APPLICATION FOR PERMIT TO DRILL						1. WELL NAME and NUMBER GORDON CREEK ST SE-32-14-8								
2. TYPE OF WORK DRILL NEW WELL <input checked="" type="checkbox"/> REENTER P&A WELL <input type="checkbox"/> DEEPEN WELL <input type="checkbox"/>						3. FIELD OR WILDCAT UNDESIGNATED

BOPE REVIEW GORDON CREEK, LLC ORDON CREEK ST SE-32-14-8 43007502530000

**Application for Permit to Drill
Statement of Basis
Utah Division of Oil, Gas and Mining**

LOCATION LAYOUT
 Section 32, T14S, R8E, S.L.B.&M.
 SE-32-14-8

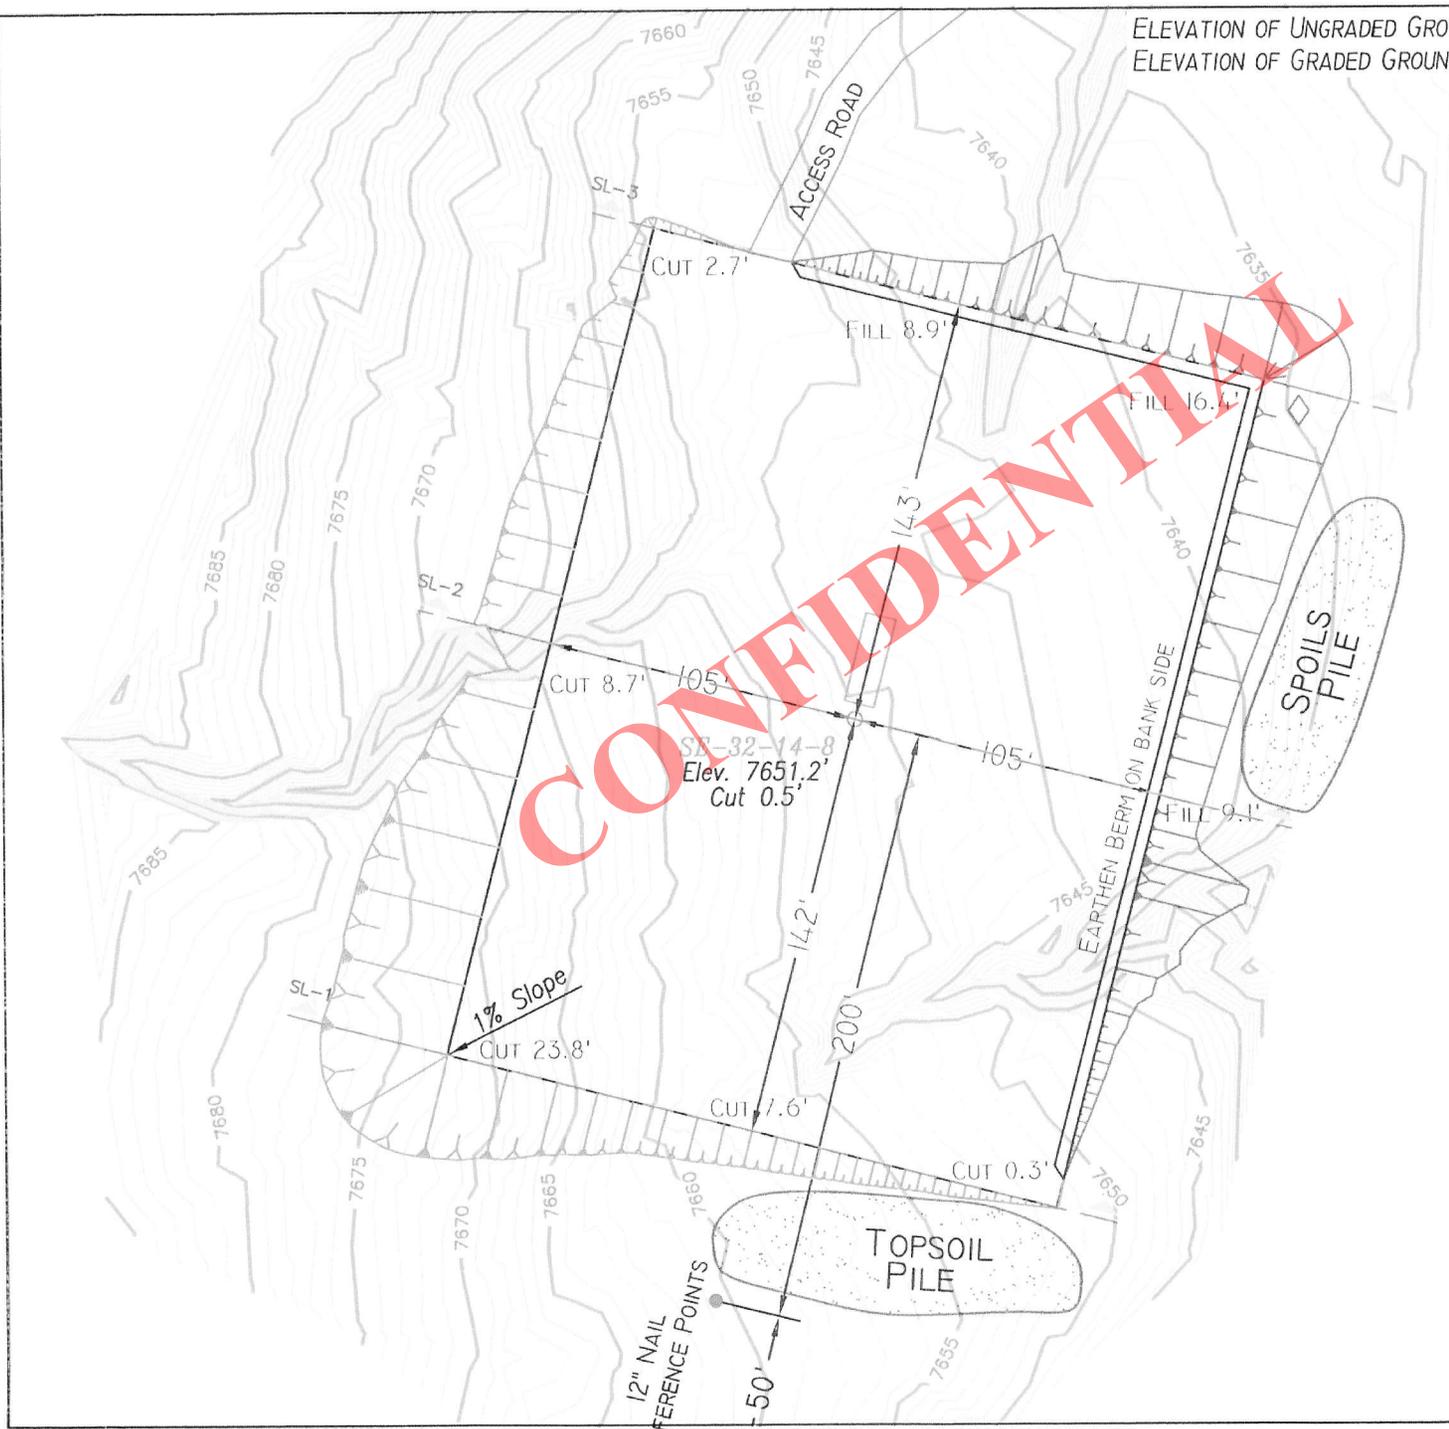
stipulations along with raptor nesting restriction pending raptor surveys. Those season dates and other pertinent information can be obtained from DWR. A diversion on the west side of the location was of concern during the pre-site and DOGM suggested that the entire location and well bore be moved east ~ 60 feet to provide more room and options to deal with this drainage and the necessary diversion that was going to be required. It was discussed during the pre-site to keep run-off from the hill spilling onto the well pad by diverting the drainage on the west side back to the south around the southwest corner of the pad and drop it into Mud Canyon at that point. This will be a rather major diversion and will take ample dirt work and potentially some rip-rap to accomplish the job. A diversion was discussed to capture smaller drainages on the west side of the pad proceeding northward.

Category	Condition
Surface	The well site shall be bermed to prevent fluids from leaving the pad.
Surface	GENERALLY: Drainages adjacent to the proposed pad shall be diverted around the location.
Surface	SPECIFICALLY: Divert major drainage on the west side of the location back to the south around the southwest corner of the location and dump it back into a finger of Mud Canyon at that point. Also create a smaller diversion ditch along the west side of the pad proceeding back to the north around the northwest corner of the pad. Both drainages should utilize ample rip-rap where necessary.
Surface	This well pad and wellbore were moved ~ 60 feet east during the presite. New surveys were shot that day and were looked at by the entire pre-site party. These drawings were submitted to the Division to be added to the APD package and to be considered for approval as the site chosen for the well pad and well bore. The operator should take measures to ensure that this "moved" pad and wellbore are constructed.

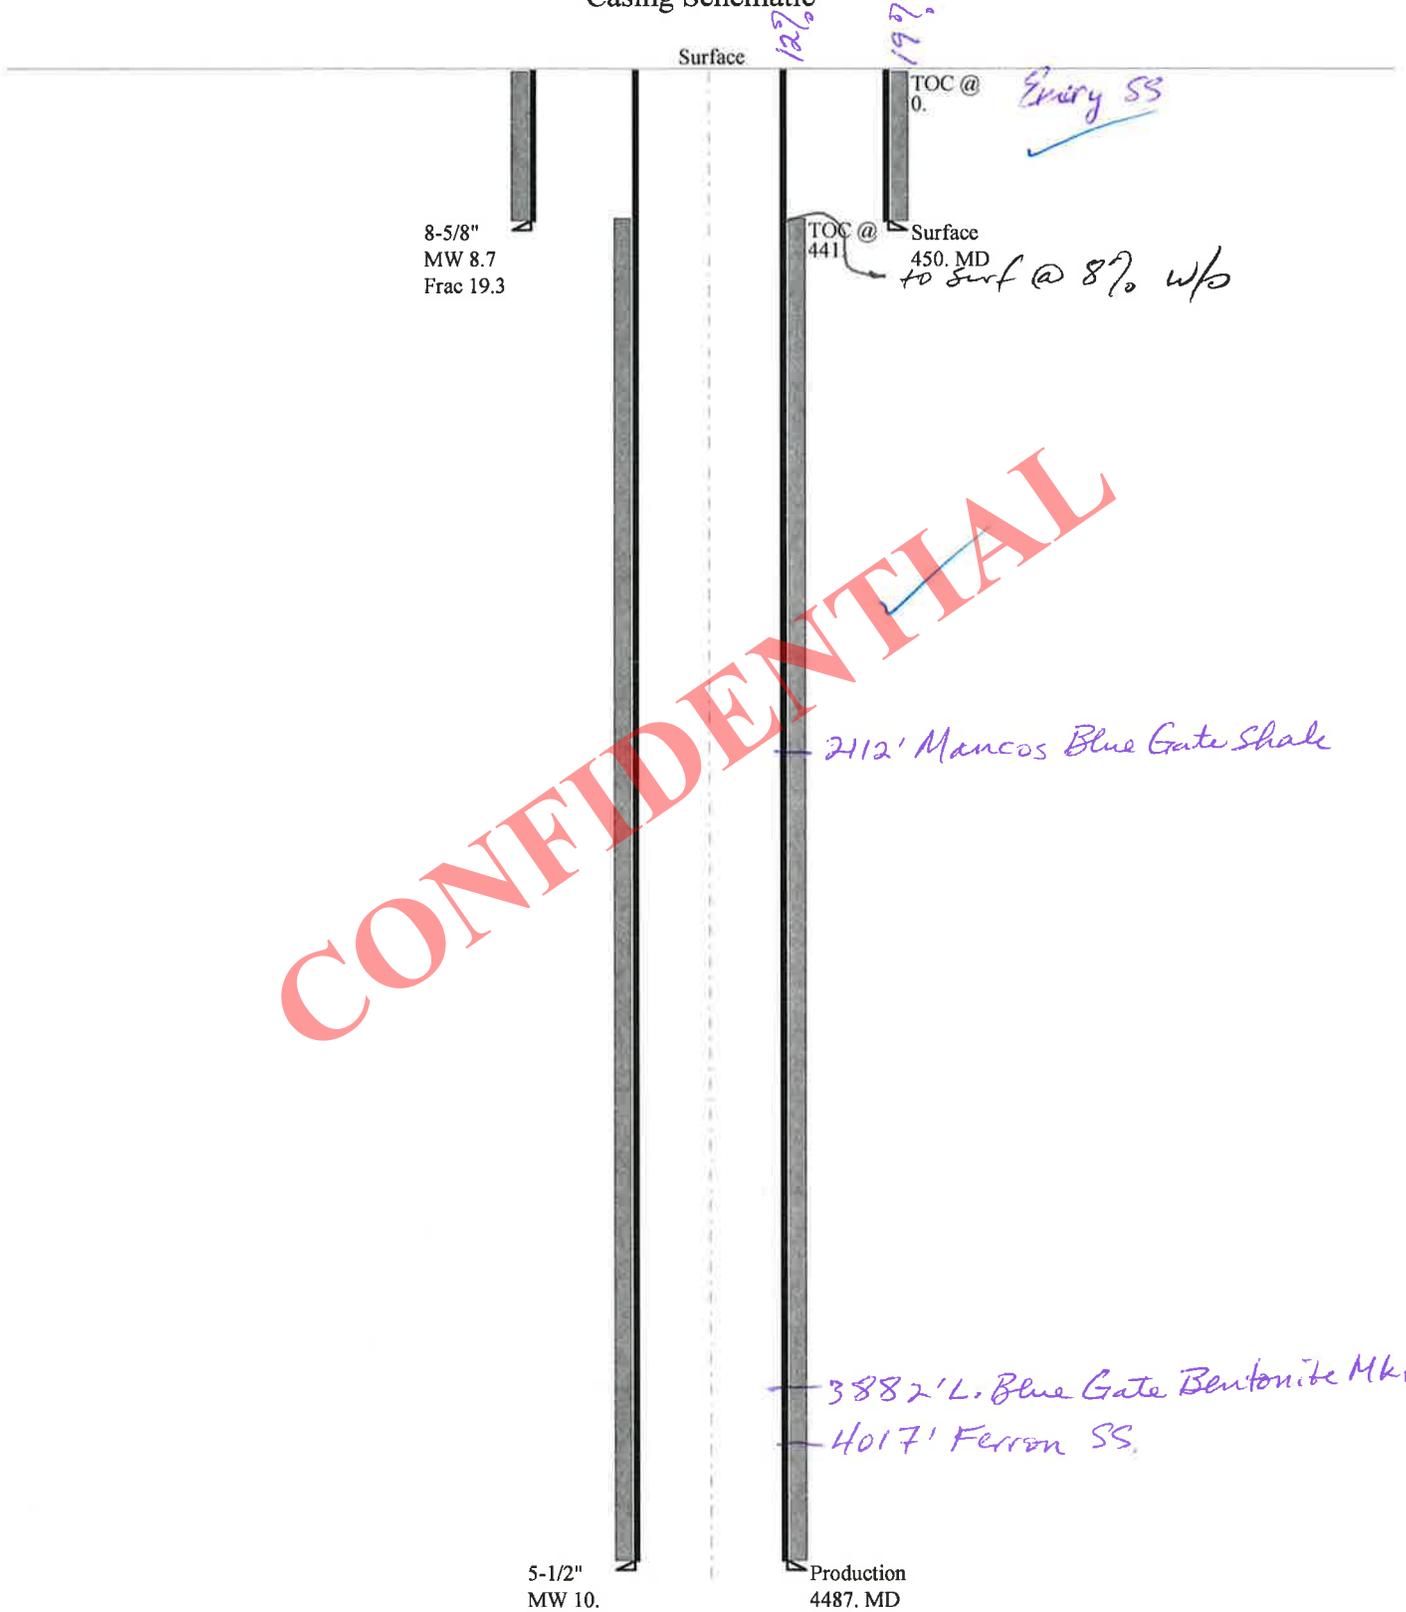
Calculations	Surf String	8.625	"
Max BHP (psi)	.052*Setting Depth*MW=	204	
			BOPE Adequate For Drilling And Setting Casing at Depth?
MASP (Gas) (psi)	Max BHP-(0.12*Setting Depth)=	150	YES <input type="checkbox"/> air drill
MASP (Gas/Mud) (psi)	Max BHP-(0.22*Setting Depth)=	105	YES <input type="checkbox"/> OK
			*Can Full Expected Pressure Be Held At Previous Shoe?
Pressure At Previous Shoe	Max BHP-.22*(Setting Depth - Previous Shoe Depth)=	105	NO <input type="checkbox"/> OK
Required Casing/BOPE Test Pressure=		450	psi
*Max Pressure Allowed @ Previous Casing Shoe=		0	psi *Assumes 1psi/ft frac gradient

Calculations	Prod String	5.500	"
Max BHP (psi)	.052*Setting Depth*MW=	2333	
			BOPE Adequate For Drilling And Setting Casing at Depth?
MASP (Gas) (psi)	Max BHP-(0.12*Setting Depth)=	1795	YES <input type="checkbox"/> air drill
MASP (Gas/Mud) (psi)	Max BHP-(0.22*Setting Depth)=	1346	YES <input type="checkbox"/> OK
			*Can Full Expected Pressure Be Held At Previous Shoe?
Pressure At Previous Shoe	Max BHP-.22*(Setting Depth - Previous Shoe Depth)=	1445	NO <input type="checkbox"/> Reasonable
Required Casing/BOPE Test Pressure=		3000	psi
*Max Pressure Allowed @ Previous Casing Shoe=		450	psi *Assumes 1psi/ft frac gradient

Casing Schematic

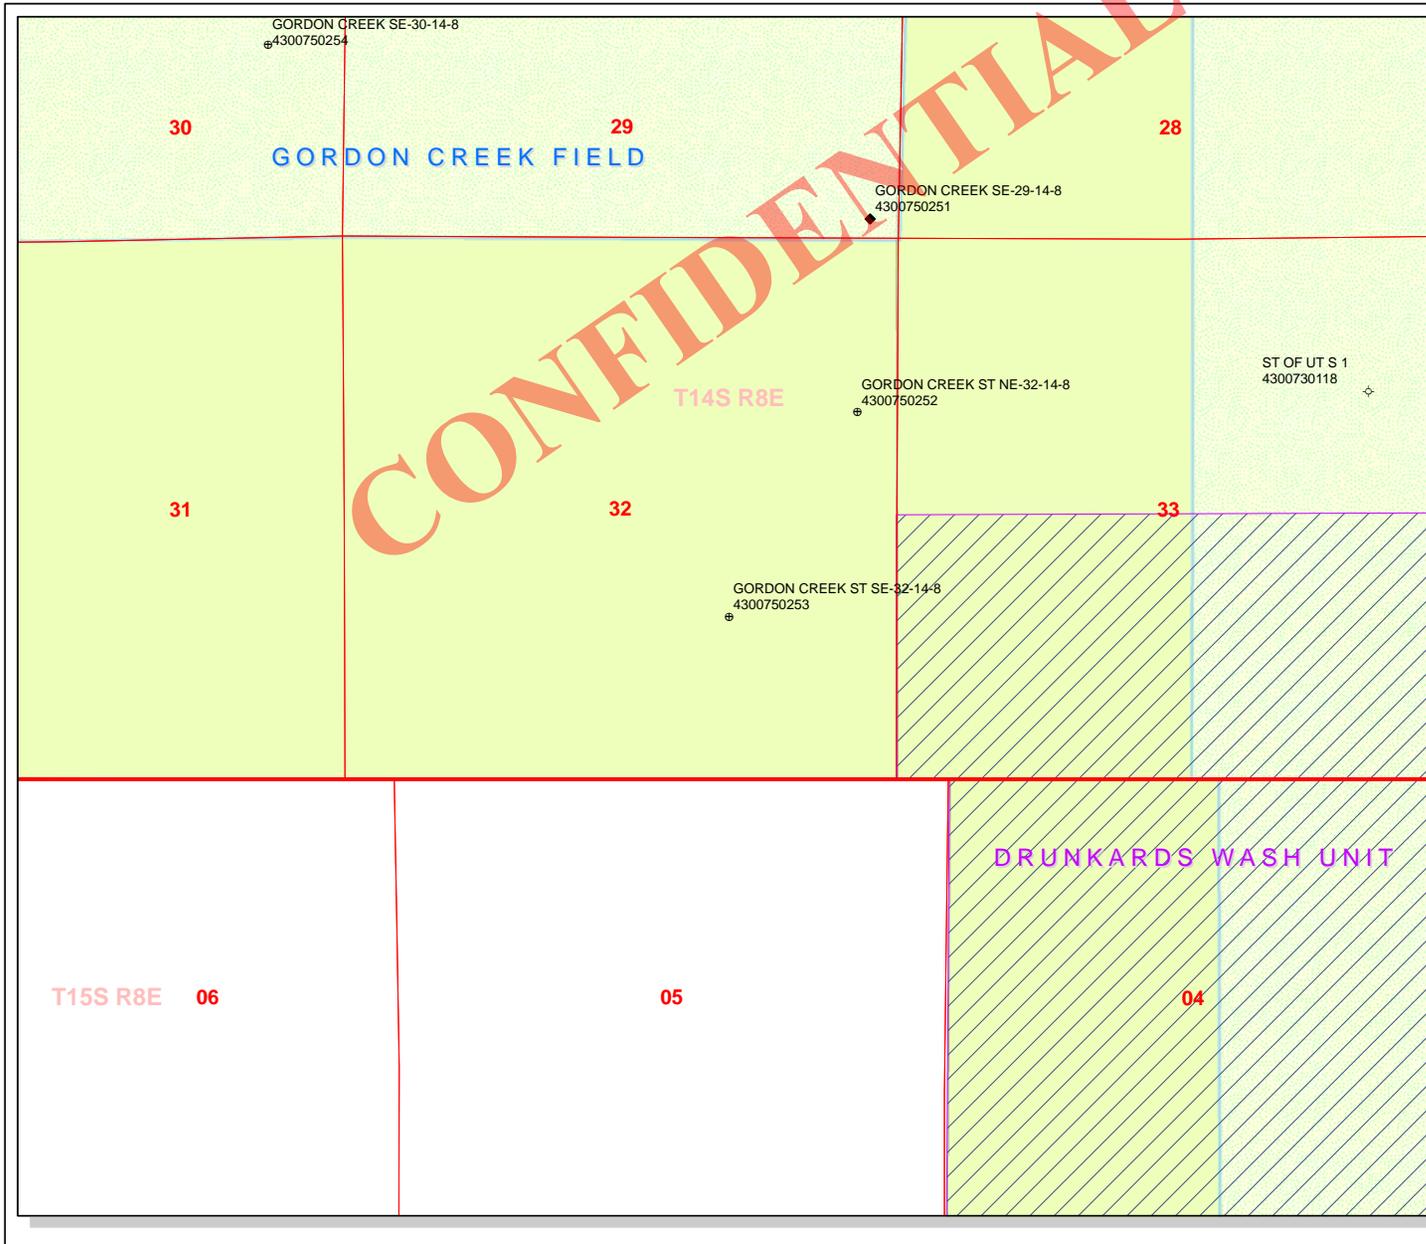
Collapse is based on a vertical depth of 4487 ft, a mud weight of 10 ppg. The casing is considered to be evacuated for collapse purposes. Collapse strength is based on the Westcott, Dunlop & Kemler method of biaxial correction for tension.

Burst strength is not adjusted for tension.
